**SPECIAL MEETING OF THE HAMBURG TOWNSHIP PLANNING
COMMISSION**

COPUD 19-001: Final site plan review for a commercial planned unit development to allow a senior housing development of the property at 4715-25-100-105 (6.5 Acres). The property is currently accessed off the end of Veterans Memorial Drive on the east side of the roadway. This senior housing development proposes a mix of independent living, assisted living, and memory care units.

To: Planning Commissioners
From: Scott Pacheco, AICP
Hamburg Township
Township Planner
Date: April 8, 2019
Agenda Item: 7
Project Number: Commercial Planned Unit Development 19-001
Project Location: Parcel #: 15-25-100-105
Owner: Hamburg Township
Applicant: Sam Martin
Agent: Lapham Associates, Scott Bell

PROJECT NUMBER: P-190043
ENGINEER: Timothy L. Lapham, P.E., P.S. 27595
REVISD: 03/28/19 per Twp Engineer's comments
DRAWN BY: S.E. Bell
SCALE: 1" = 40'
SHEET C-3

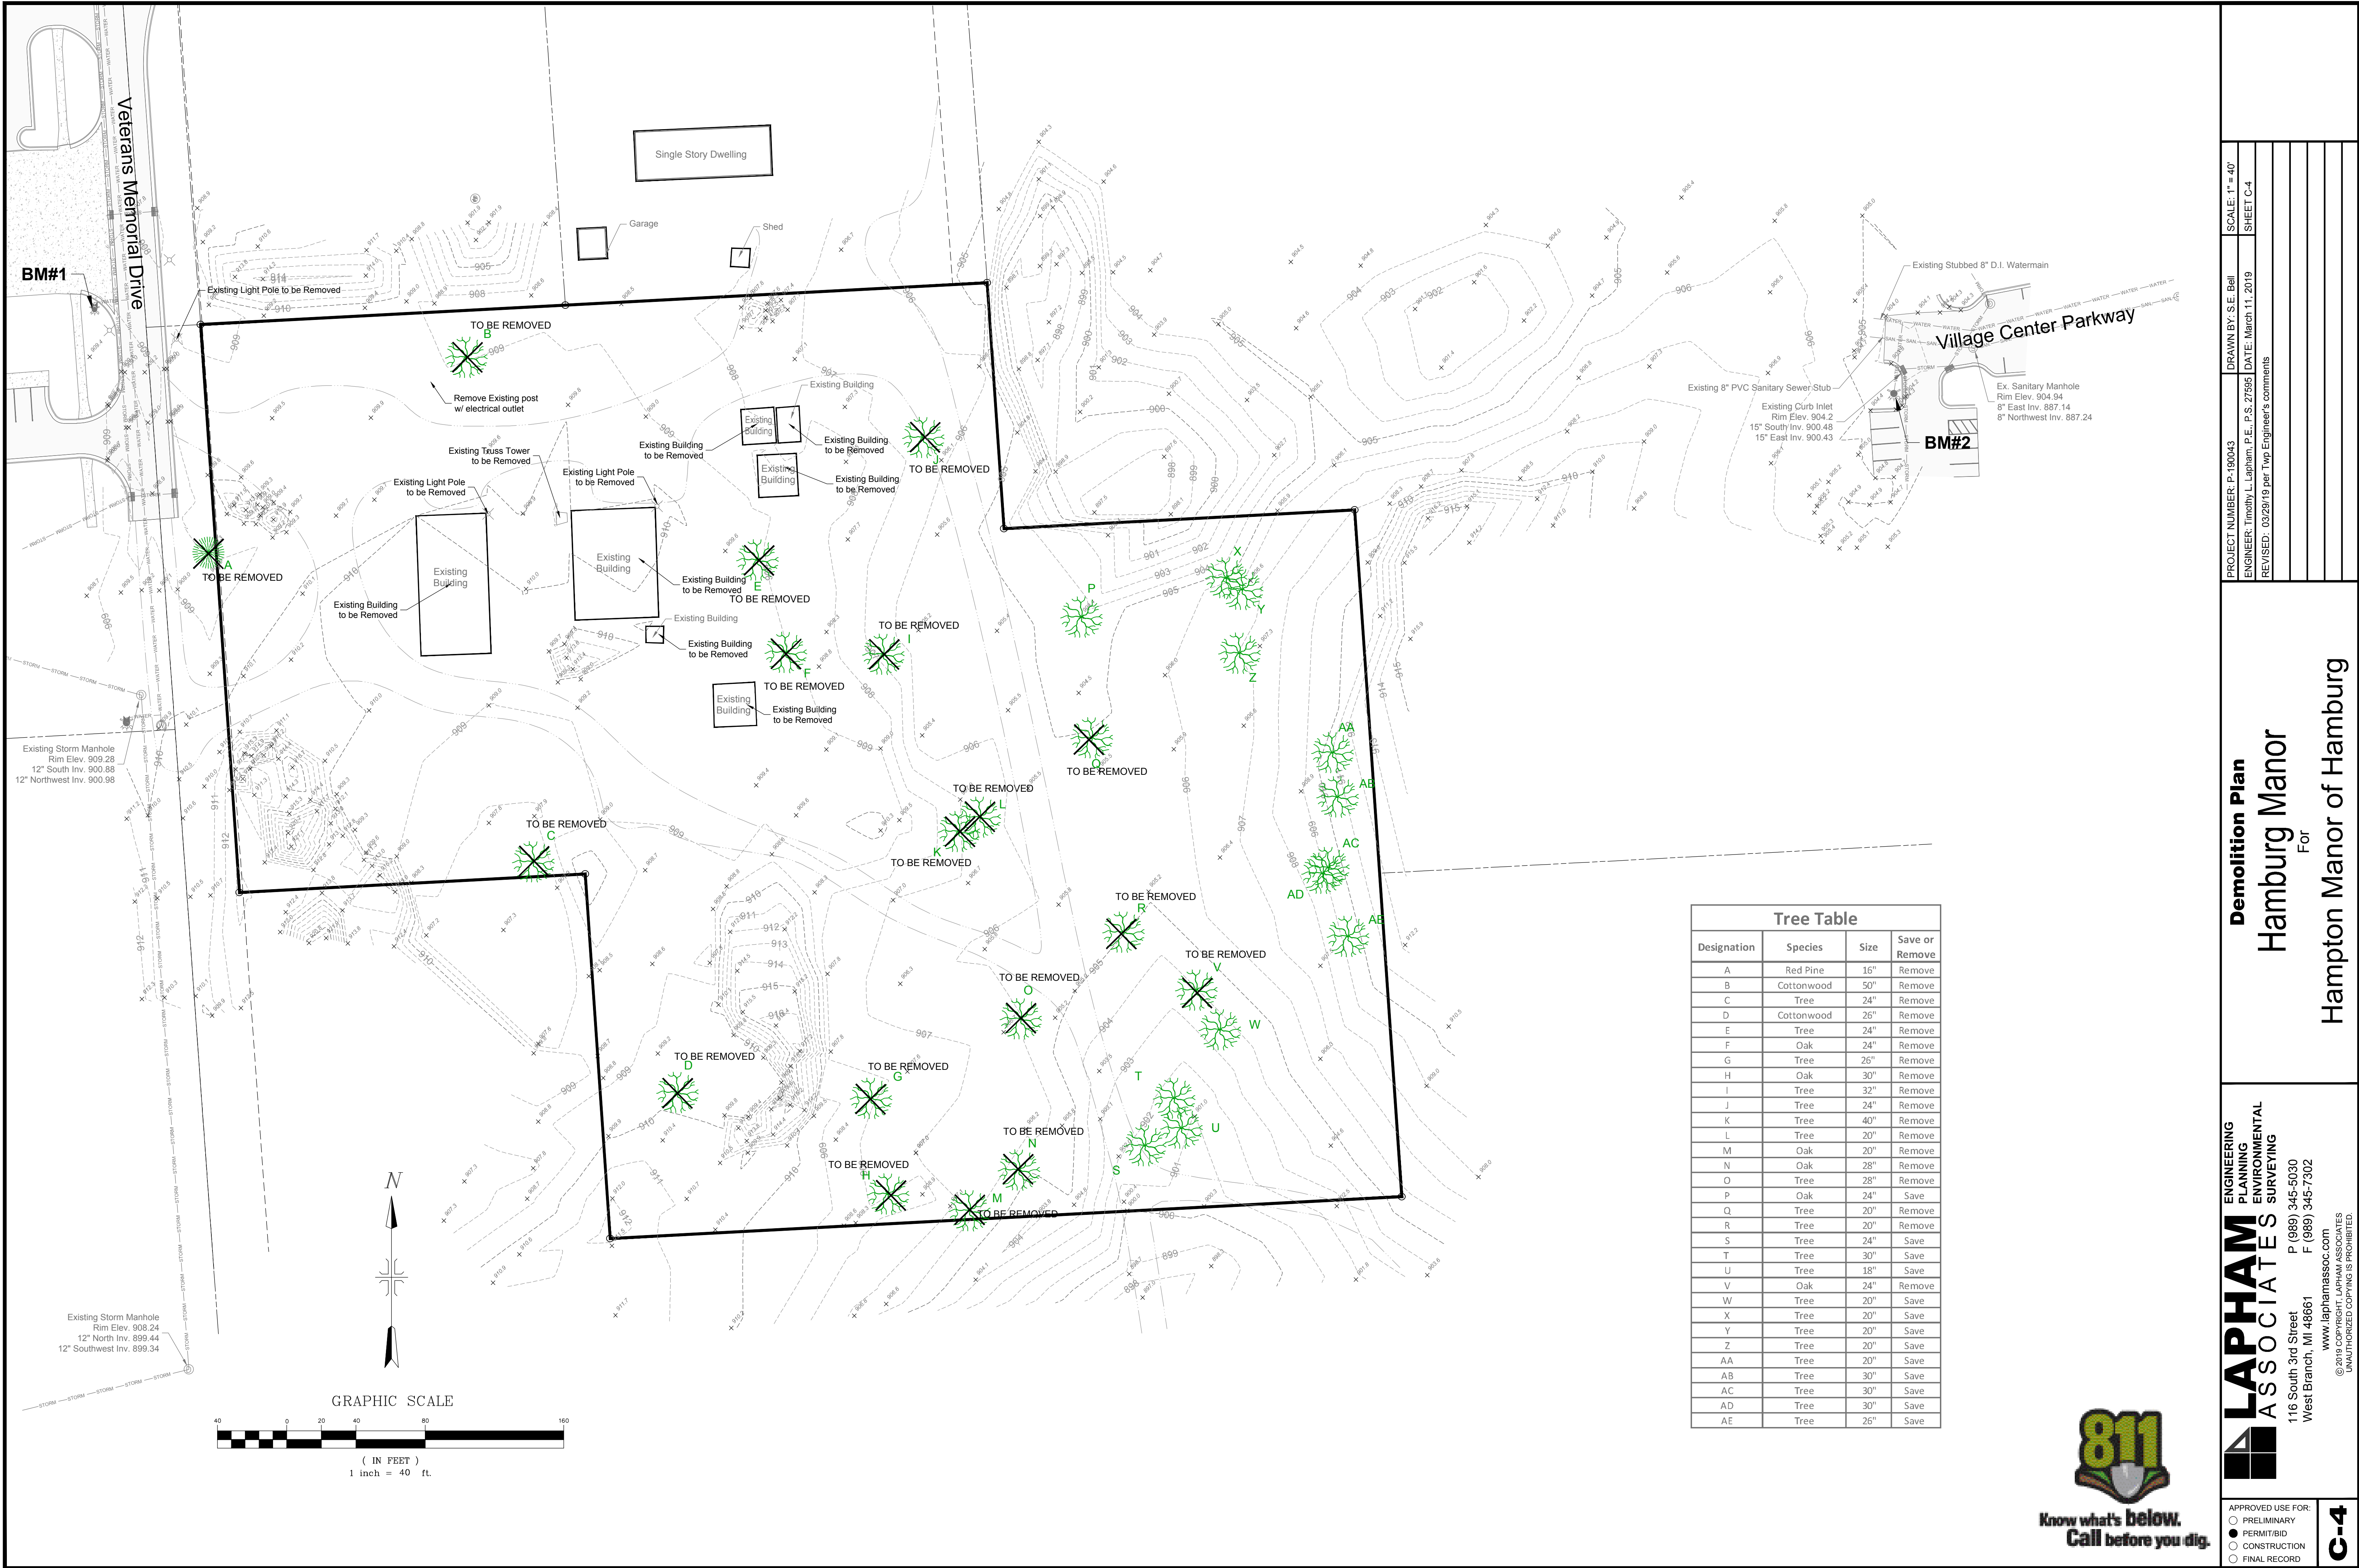
4. In general, the grading plans appear to be incomplete. Sheet C-3, Existing Topographic Survey, includes unlabeled proposed contours. Sheets C-15 and C-16, Grading Plan and Off Site Grading Plan, do not show how the proposed contours relate to the existing contours. The information provided needs to be clarified for further review. The proposed contours should be labelled and clearly identified.
5. Any offsite grading will require easement from the subject property owner. In addition to the proposed roadway connection to Village Center Parkway, offsite grading is shown on the northeast corner of the site, and the southern portion of the site to adjust the existing gravel driveway to the south.
6. Additional detail is needed on the northeastern and southern handicap parking/ ramp arrangements.

4. The existing contours on the existing topographic survey sheet C-3 are labeled and there are no proposed contours shown on this plan. The proposed contours are shown on Sheets C-15 and C-16. The proposed contours have been labeled and the existing contours have been added to clarify the relationship between the two.
5. We are aware that any work offsite will require an easement. We understand that negotiations have been underway to obtain said easements but don't know that status of these negotiations.
6. Additional proposed spot elevations have been added to the two handicapped parking areas similarly to the other to help clarify the intention of the grading on Sheet C-15.
